**SUBJECT: Third VIRP Semi-Annual Summary/Statement Progress Report
Former Macon 2 MGP Facility
HSI #10692
Macon, Bibb County, Georgia
GEC Job No. 130659.241**

Re: Second Semiannual VIRP Progress Report, April 18, 2017
Macon Former Manufactured Gas Plant 2, HSI Site No. 10692
Intersection of Willow Street and Spring Street Lane, Macon-Bibb County
Parcels R07 I-03 I 6 (OC98-5J), R073-0033 (OC99-4A), and R073-0398 (OC99-4AB)
Portions of Right-of-Way of Willow Street and Spring Street Lane GEC Job No. 130659.241

Milestone Schedule

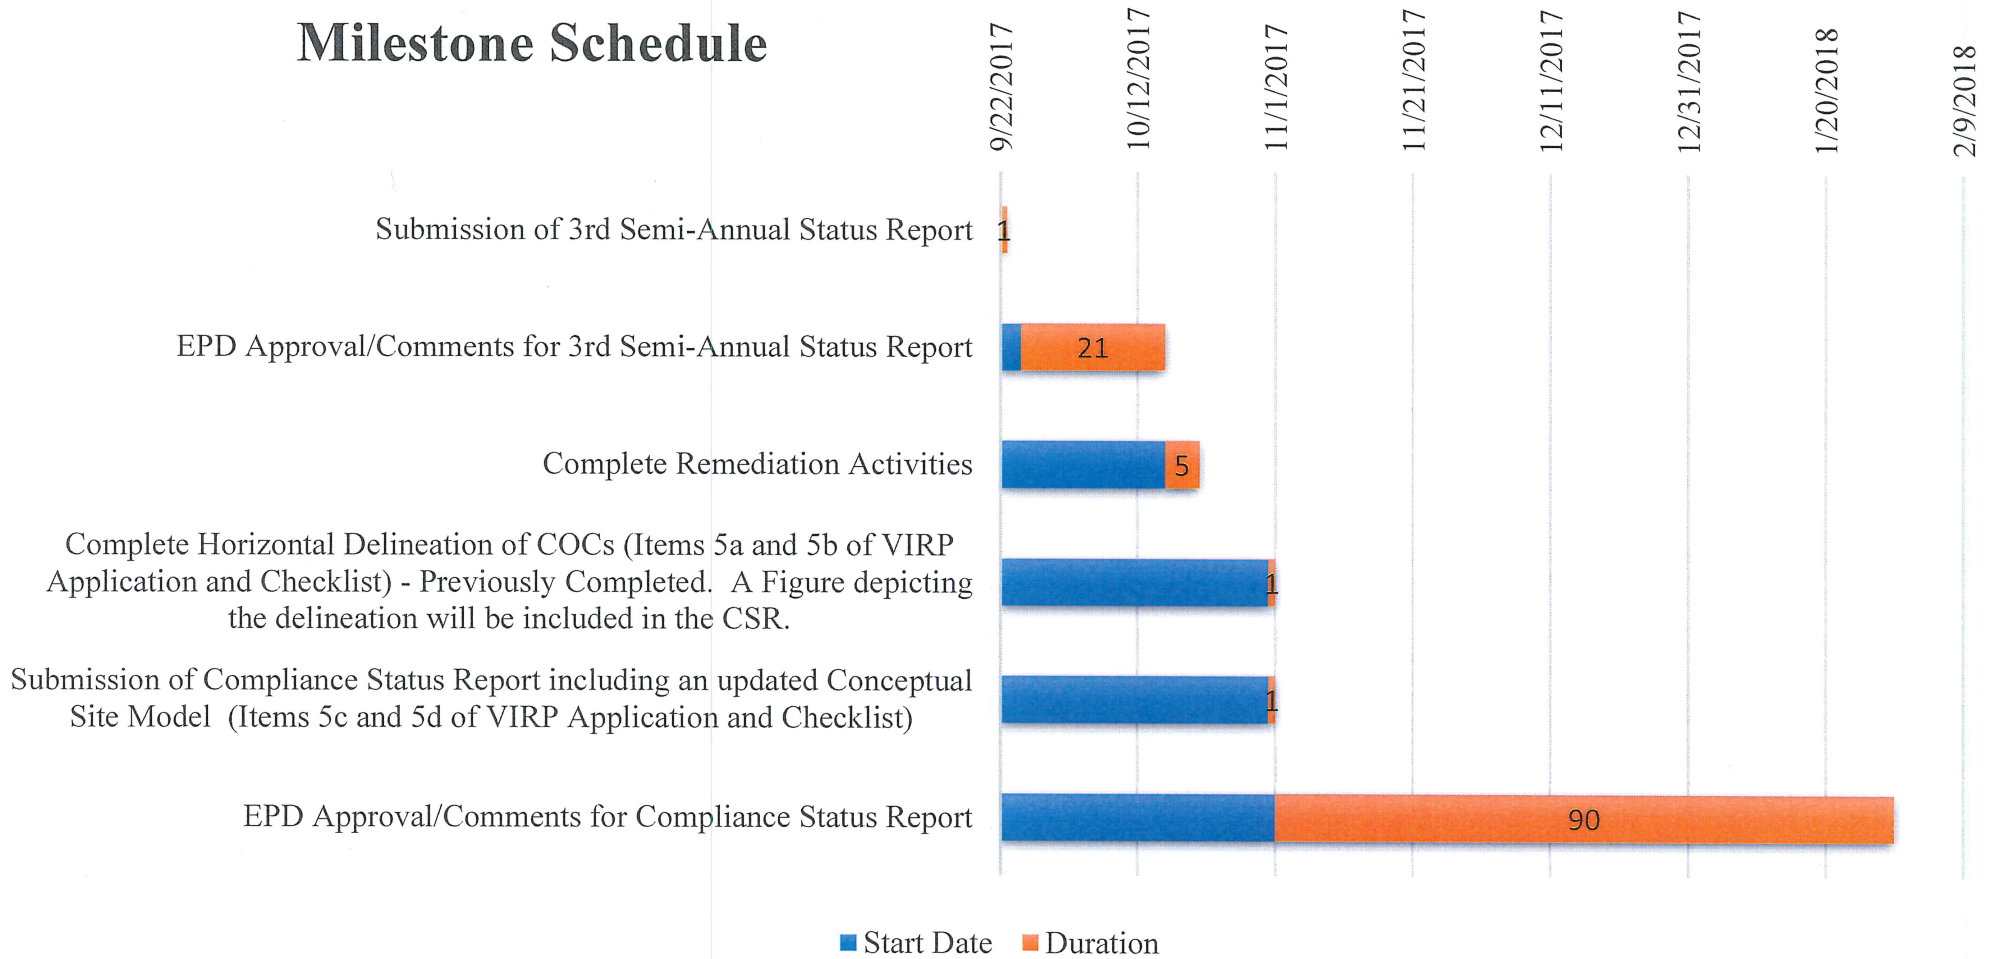
5. Section 8.0 of the 2nd Progress Report provides a proposed schedule of VRP Activities. Prior to initiation of the proposed soil excavation activities, please submit a revised milestone schedule of VRP corrective action activities (Gantt style format preferred) to include detailed remediation activities from start-up to completion, submittal of semiannual progress reports, and the remaining generic milestones found in Section 5a through 5d of the VRP Application Form and Checklist. EPD noted the proposed expedited submittal of the final CSR by September 2017, but please note that June 22, 2020 remains effective as approved in EPD's June 22, 2015 VRP approval letter.

A revised milestone schedule of VRP corrective action activities has been submitted with the 3rd Progress Report.
